Field Change Requests

**NW Natural Pre-Remedial Design Data Gaps Sampling
US Moorings Project Area – Fall 2020
Field Change Request Form**

Project Name: US Moorings Project Area **Subconsultant:** Anchor QEA, LLC

Field Change Request (FCR) Title: Subsurface Sediment Sampling Intervals for Alkylated PAH and TPH Analyses

USMPDI-079

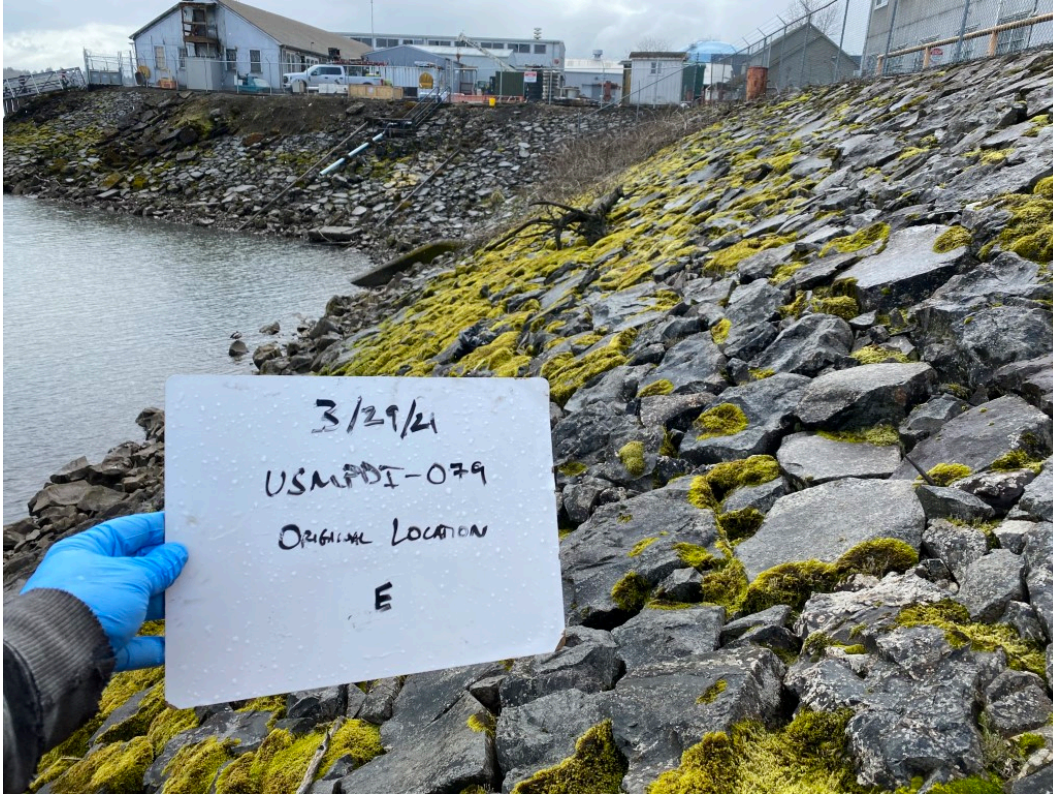
Facing East, No Erodible Soils Present

USMPDI-081

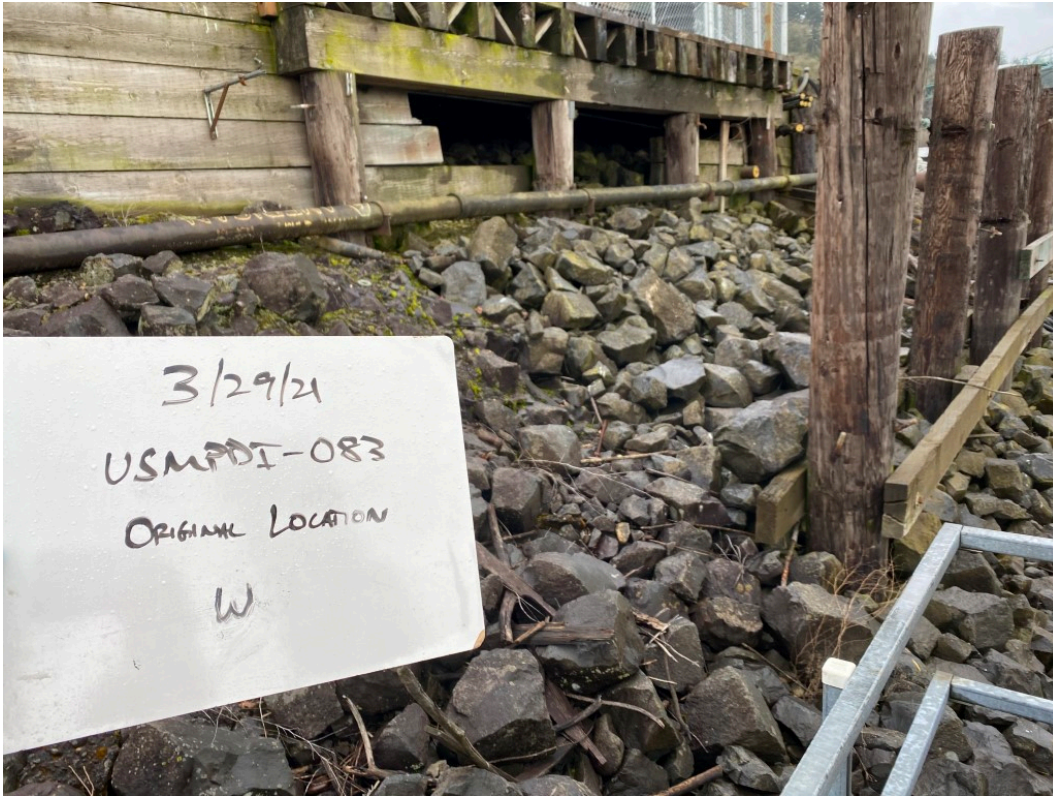
Facing North, No Erodible Soils Present

Figure 1
Revised Surface and Subsurface Sediment Sampling Locations
 Field Change Request No. 4
 US Moorings Project Area
USMS0024009

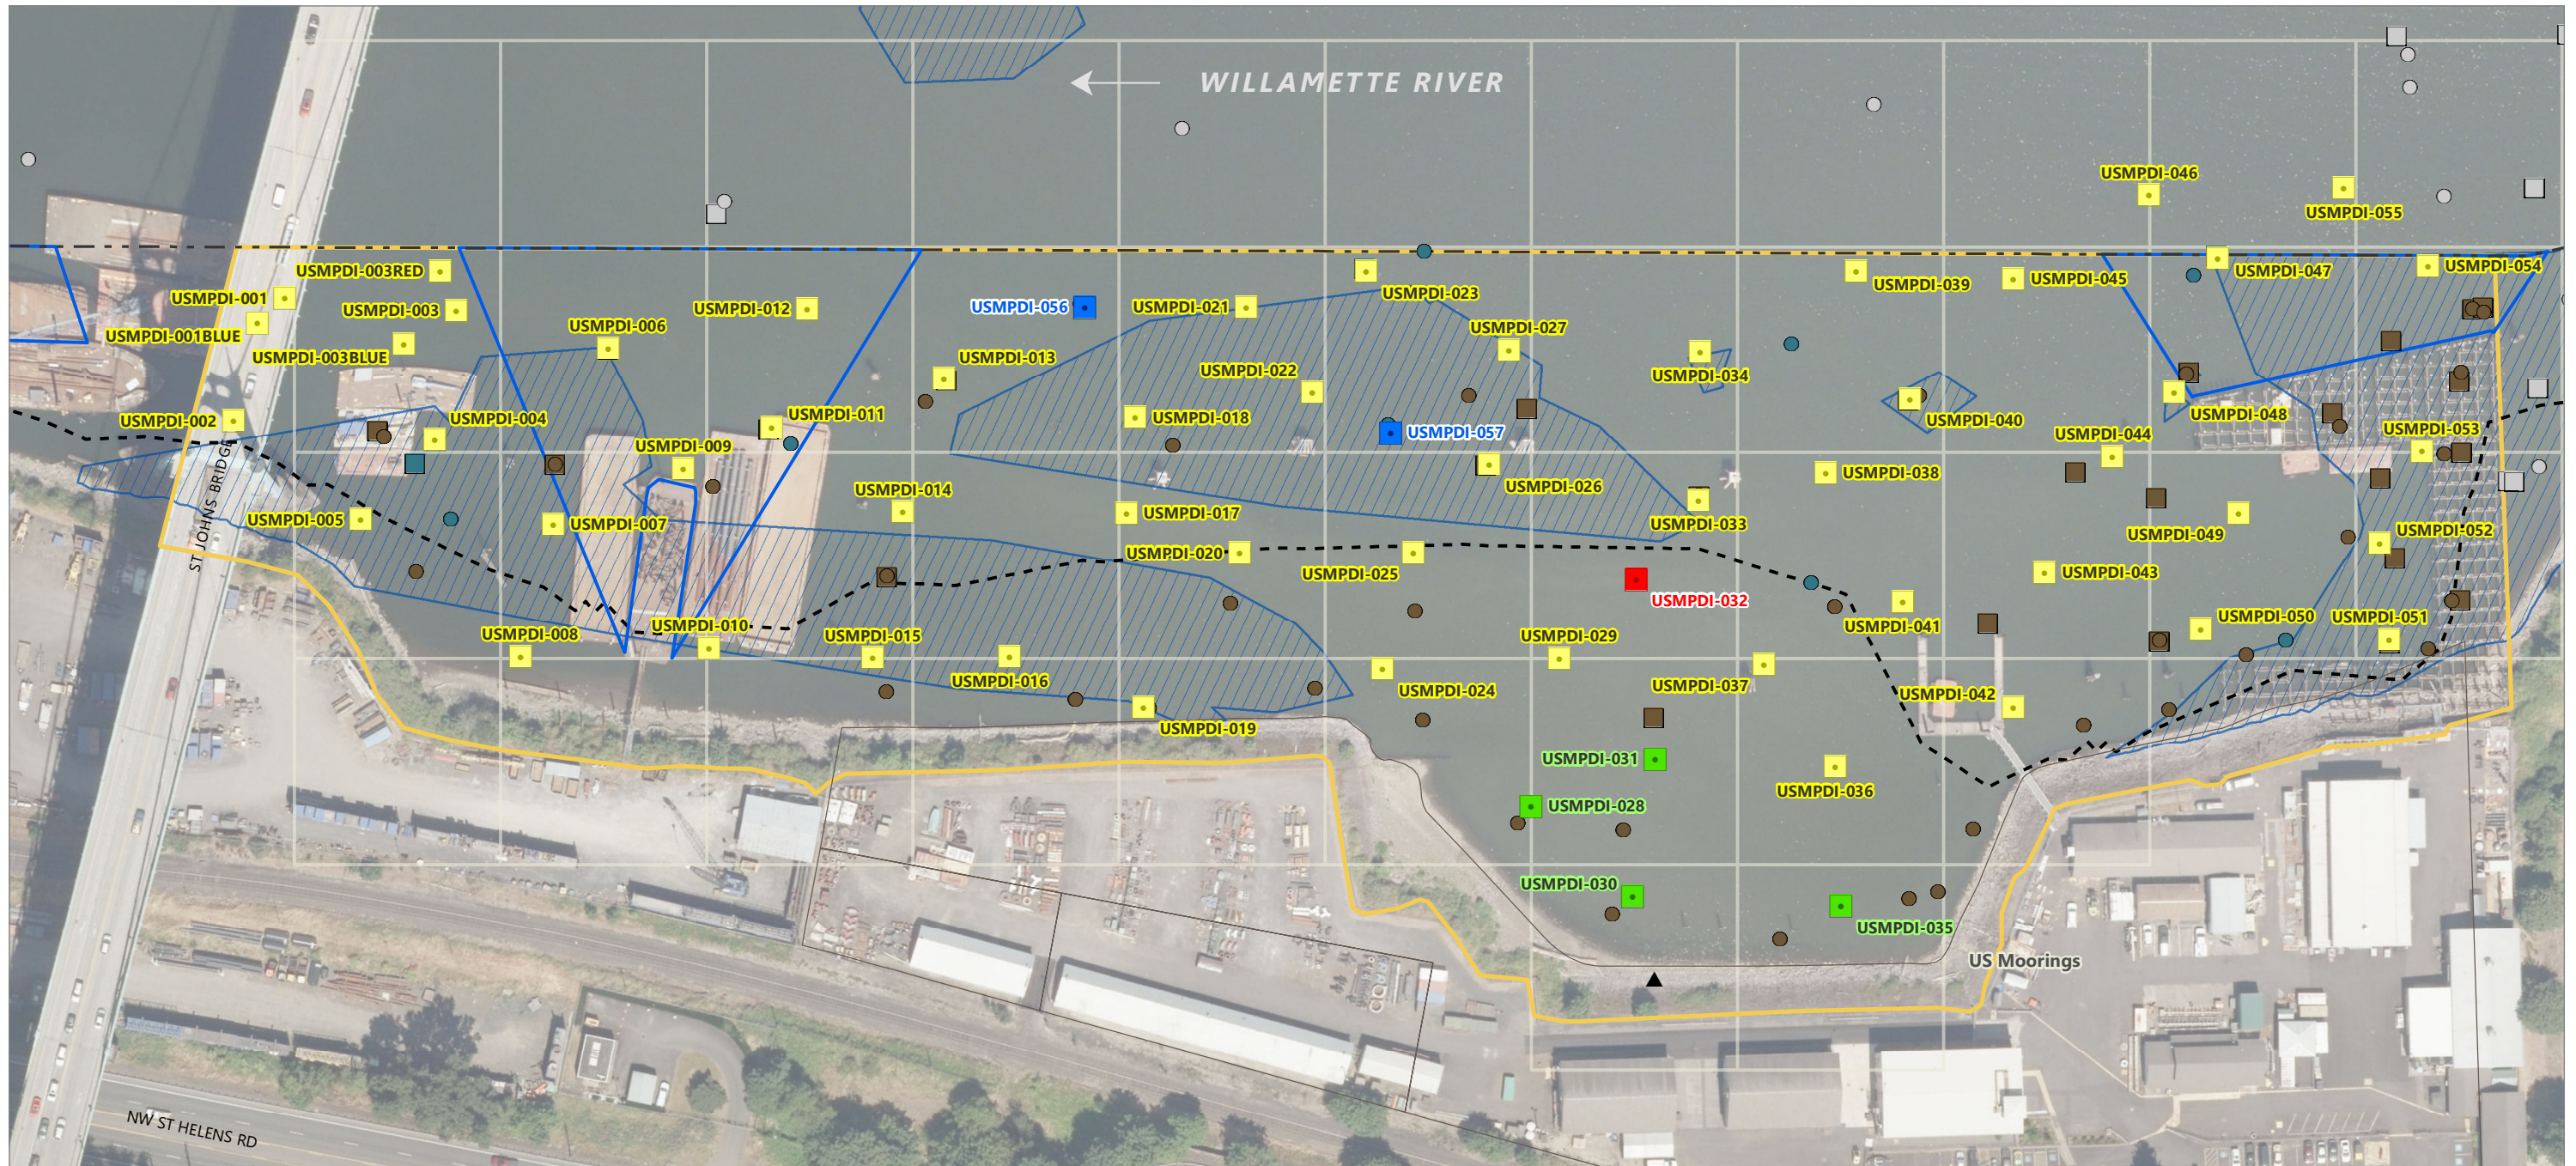
Recommended Change
<p>NW Natural proposes to remove station USMPDI-032 from the PDI sampling program due to sufficient data density in this area and to use an 8-foot coring assembly to collect stations USMPDI-028, USMPDI-030, USMPDI-031, and USMPDI-035 due to anticipated shallow refusal and insufficient river water surface elevations to collect the proposed 16-foot cores.</p>
